## LINCOLN CITY/LANCASTER COUNTY PLANNING STAFF REPORT

for May 12, 2004 PLANNING COMMISSION MEETING

**P.A.S.:** Preliminary Plat #04004

**PROPOSAL:** To create 336 lots and five outlots.

PRELIMINARY PLAN  
SHEET 1 OF 1

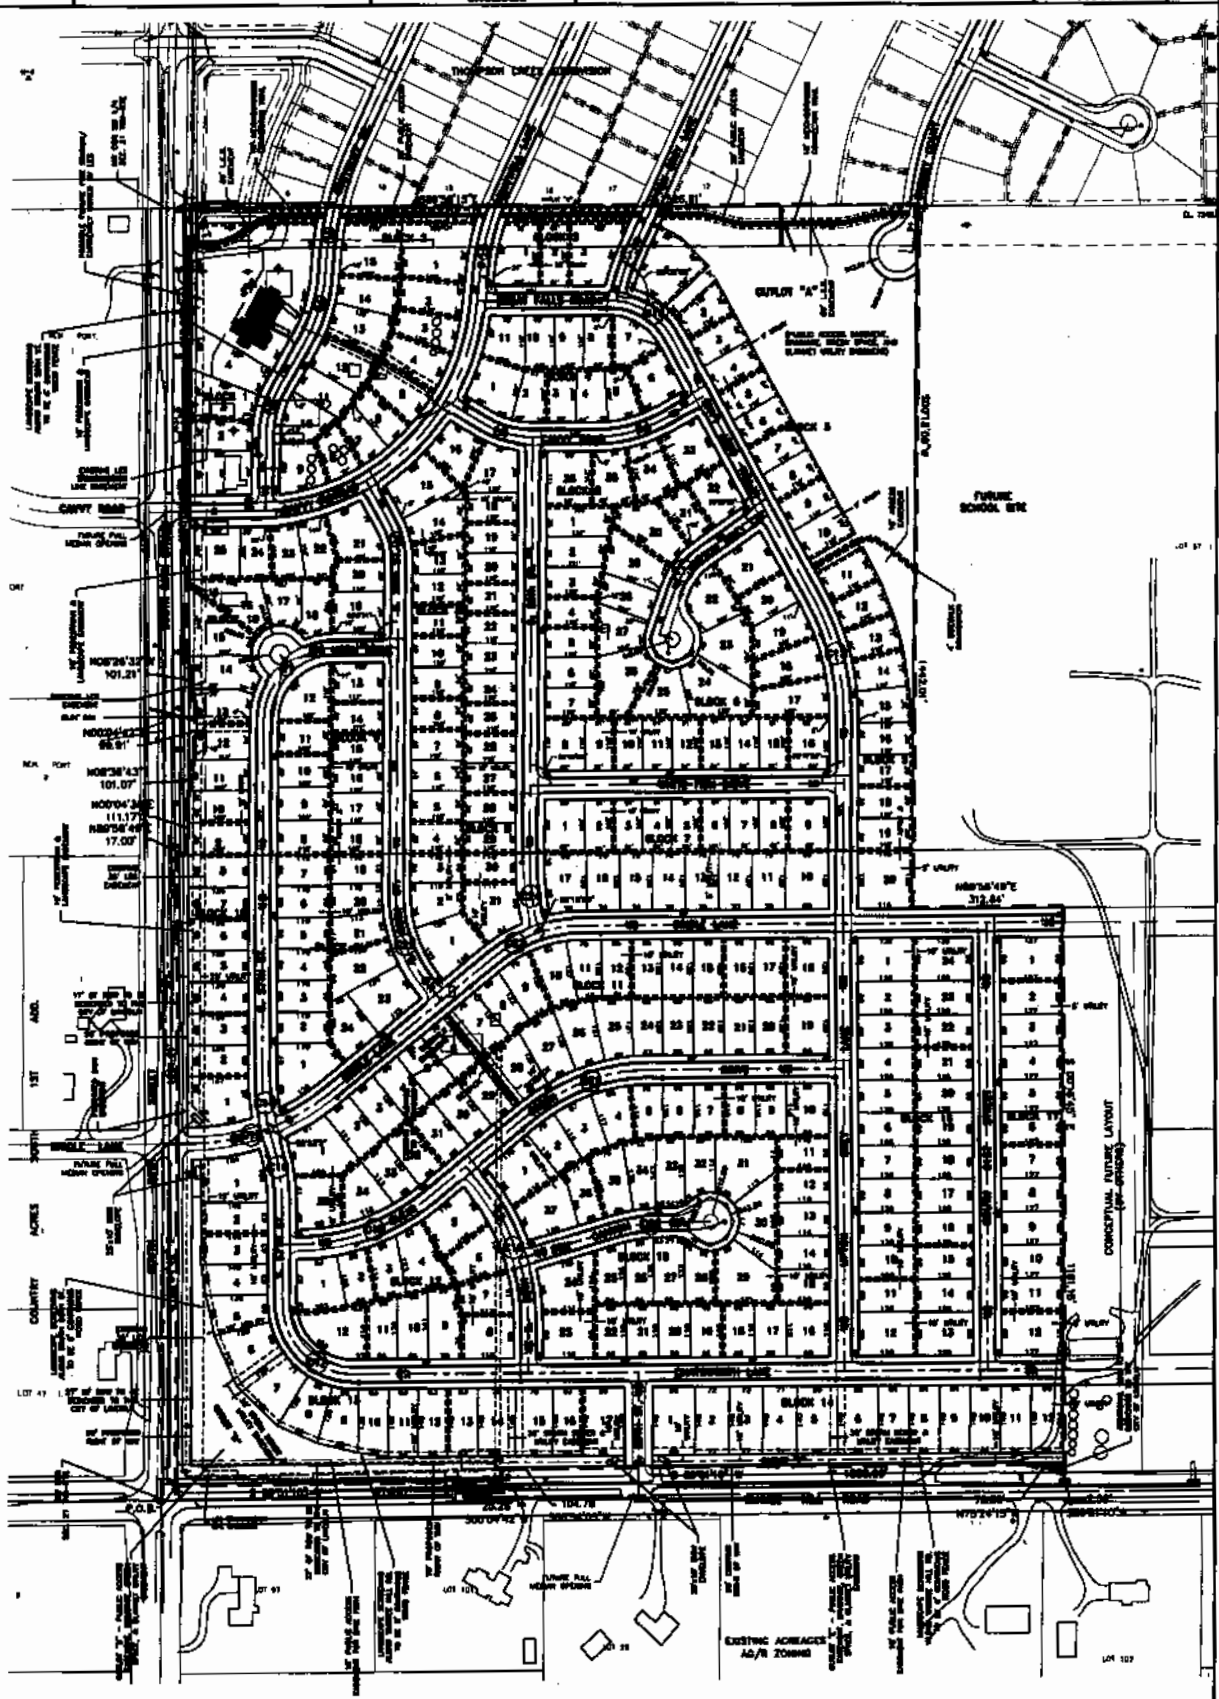
12. The street name Munsteadwood Lane must be deleted, and Bridle Lane must be shown to extend from South 56<sup>th</sup> Street to the east boundary of the plat. Additionally, delete Munsteadwood from General Site Note #20 and from Waiver Note #4 on Sheet 1 of 9.

20. Outlot C must be re-labeled as Outlot D. Additionally, it does meet the minimum lot area requirement for the R-3 zoning district, and a waiver must be requested and approved for it to be allowed as shown.

21. Lots 11-13, Block 10 do not meet the minimum depth requirement for a lot adjacent to a major street. While it is noted on the plat that this waiver was previously approved, it must be requested and approved again as part of this plat to be allowed.

22. Lot 4, Block 1 exceeds the maximum width to depth ratio and a waiver must be requested and approved as part of this plat to be allowed.

*The corrections have been made to the plans.*

*The corrections have been made to the plans.*

*This has been noted on the plans. We are requesting the waiver for the minimum lot depth.*

*This has been noted on the plans. We are requesting the waiver for the width to depth ratio.*
